CALIFORNIA COASTAL COMMISSION

February 18, 1999

RE: **Notice of Impending Development 2-98, Pursuant to the University of California Santa Barbara Certified Long Range Development Plan (LRDP) for Public Hearing and Commission Action at the meeting of March 9-12, 1999, in Carmel.**

EXHIBIT 4
UCSB NOID 2-98
Bicycle Route Network
(Figure 19 UCSB LRDP)

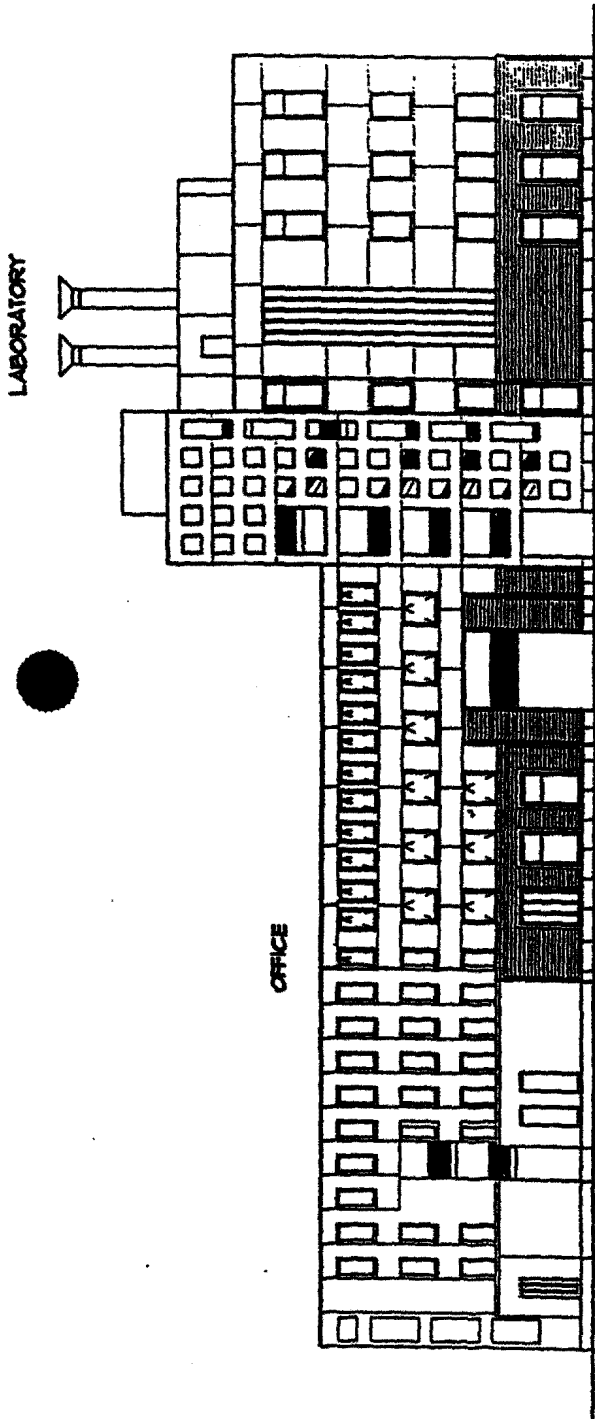
Prior to the commencement of development, the University shall submit, for the review and approval of the Executive Director, revised plans which provide for bicycle path improvements to be incorporated into the design of the project adequate to connect that portion of the existing bicycle route network located to the north of the project site to that portion of the existing bicycle route network located to the south of the project site consistent with the bicycle path configuration shown in Figure 19 (Bicycle Route Network) of the UCSB Long Range Development Plan.

The proposed project includes the demolition of an existing bicycle path which currently crosses the project site. The existing bicycle path on site runs from north to south and serves to connect that portion of the existing bicycle route network located to the north of the project site to that portion of the existing bicycle route network located to the south of the project site as shown on Exhibit 4 (Bicycle Route Network). The Commission notes that although the project plans submitted by the University indicate a potential location on the project site for bicycle path improvements, the project plans also specifically indicate that such improvements are not included as part of the proposed project. Further, although the Notice of Impending Development (NOID) submitted by the University indicates that bicycle access would be accommodated on site; University staff have confirmed that the submitted project plans, in contradiction to the project description of the submitted NOID, do not provide for the replacement of the existing bicycle path on site to be demolished. Policy 30210.15 of the LRDP requires the University to maintain and improve bicycle and pedestrian accessways to the beach as necessary to protect sensitive habitat areas and public safety. If the existing bicycle path on site is demolished without replacement, bicycle riders will be forced to use busy pedestrian-filled sidewalks and/or Lagoon Road (restricted to automobile access only) which would result in potential adverse effects to public safety. In addition, the demolition and non-replacement of the existing bicycle path located on the project site or reconstruction of the path in an inappropriate configuration would not be consistent with Figure 19 (Bicycle Route Network) of the LRDP which specifies the location of all existing and proposed bicycle routes on the Main Campus. Therefore, in order to ensure that the proposed project is consistent with the LRDP, Special Condition One (1) requires the University to submit, for the review and approval of the Executive Director, revised plans which provide for bicycle path improvements to be incorporated into the design of the project adequate to connect that portion of the existing bicycle route network located to the north of the project site to that portion of the existing bicycle route network located to the south of the project site as consistent with Policy 30210.15 and with the bicycle path configuration shown in Figure 19 (Bicycle Route Network) of the LRDP.
